Change Order Request

PFAS Well 15

Field Order 11- Curb at Generator Area

FOUNDATION PLAN

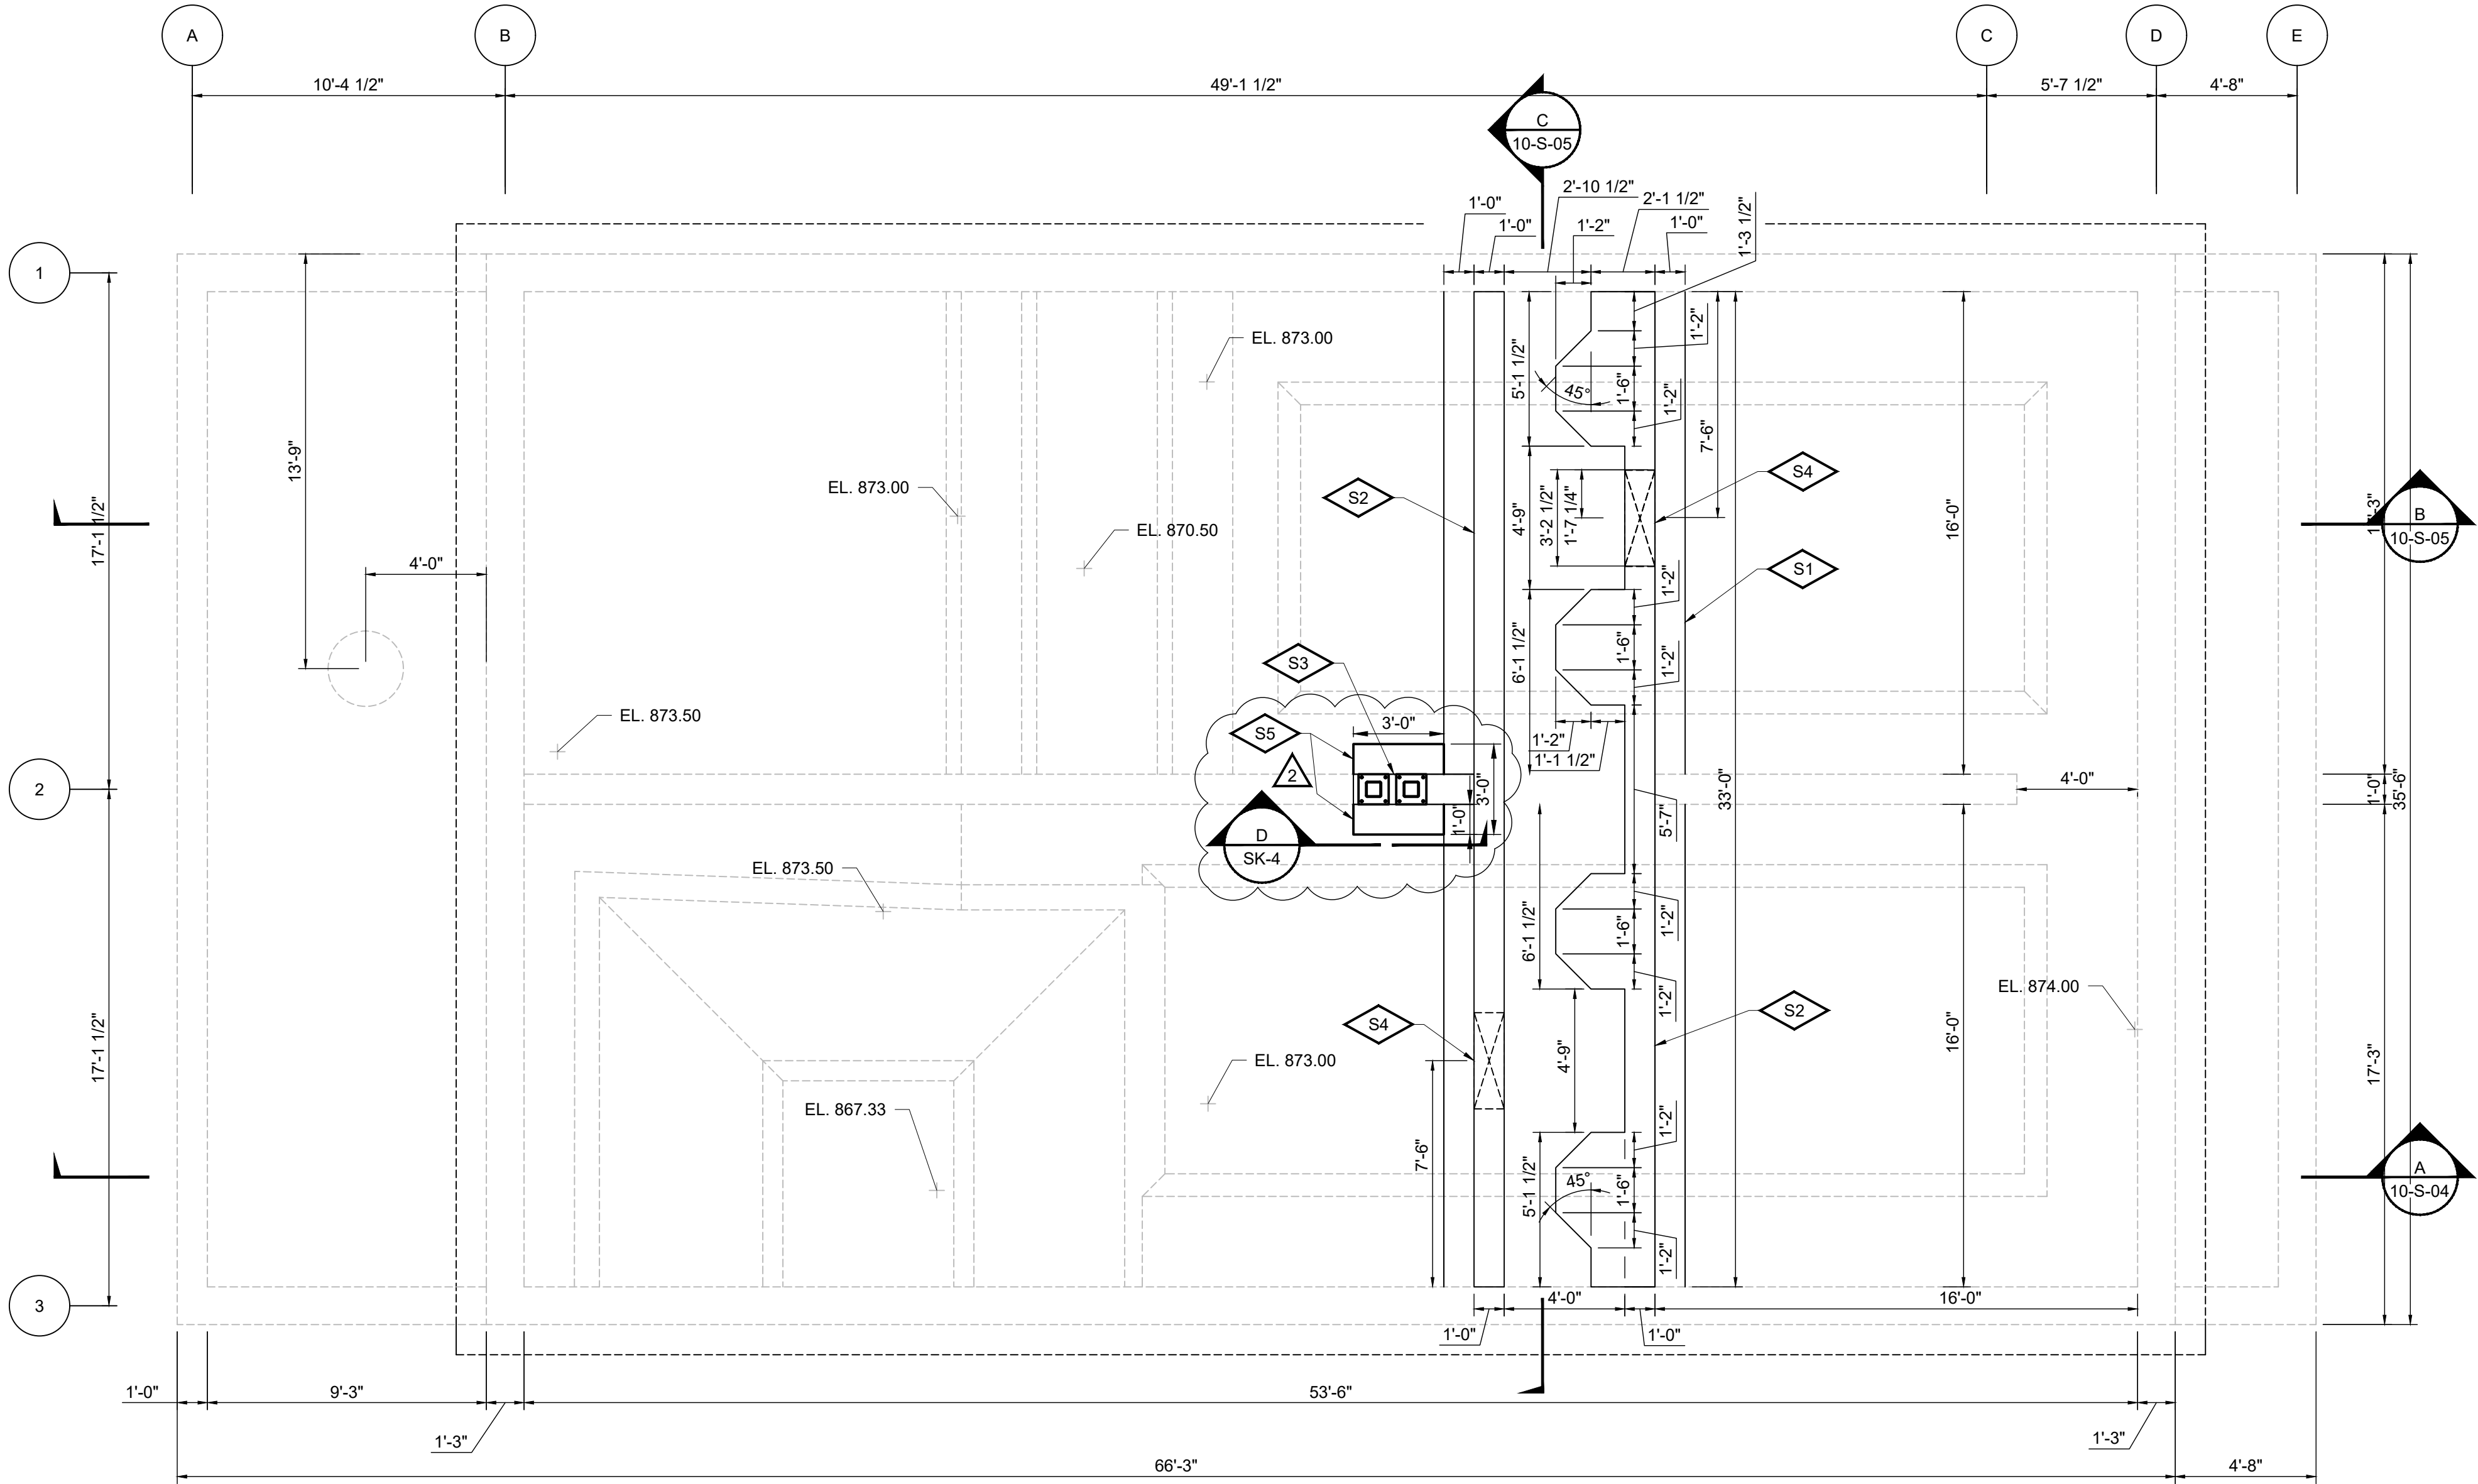
1. The existing 5 to 6-inch deep sawcuts at the two locations are to be cleaned out and filled with epoxy by gravity feed with resin method in accordance with the manufacturer's recommended installation procedures.
 - a. Reference: American Concrete Institute's' ACI RAP Bulletin 2 – Field Guide to Concrete Repair Application Procedures, Crack Repair by Gravity Feed with Resin.
 - b. Epoxy material shall be Sikadur-32 Hi-Mod manufactured by Sika Corporation or engineer's approved equivalent.
2. Install steel columns as shown on the attached revised drawing Nos. 10-S-01 and 10-S-08, dated 10/21/24 and Sketch SK-4 dated 10/21/2024 to support existing slab and beam floor system. SK-4 will be incorporated into the As-Built drawings when project is completed.
3. Provide cost and schedule impacts, if any, for this work to AECOM and Owner for review prior to commencement of work.

- S1 CONSTRUCT BASE SLAB TO BE PLACED ON TOP OF EXISTING SLAB
- S2 CONSTRUCT 12-INCH CONCRETE WALL
- S3 NEW OPENING IN WALL TO PROVIDE FLOW BETWEEN TANKS
- S4 ACCESS MANWAY OPENING IN WALL. SEE DETAIL SHEET 10-S-06.
- S5 REFER TO DETAILS ON COLUMN AND FOUNDATION. DWG. SK-4. RESPONSE TO RFI #35.
